Service Bulletin

Bulletin No.: PI0887B

Subject: Pulsating/Rotational Noise from Right Rear of Vehicle on Brake Apply

Models: 2012-2013 Chevrolet Cruze
Equipped with Drum Brake (RPO J93)
Vehicles Built Prior to VIN Breakpoint D7161078

2965726

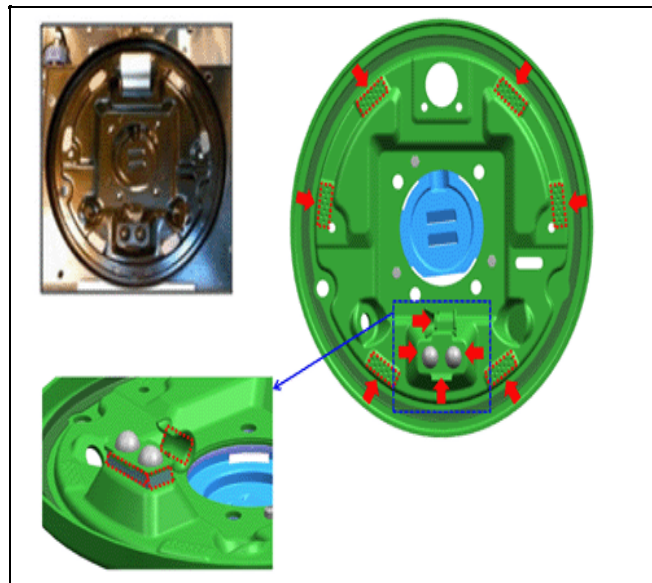
Some customers may comment about a pulsating/rotational noise coming from the right rear of the vehicle during brake apply.

This noise may be caused by an interaction between the brake drum and brake shoe.

The right rear brake drum and rear brake shoes need to be replaced including applying a high temperature grease, GM P/N 12345996 (in Canada, 10953501), or equivalent, on all the locations of the backing plate as shown in the illustration above.

Note: DO NOT replace the left rear drum as this noise condition only pertains to the right side.
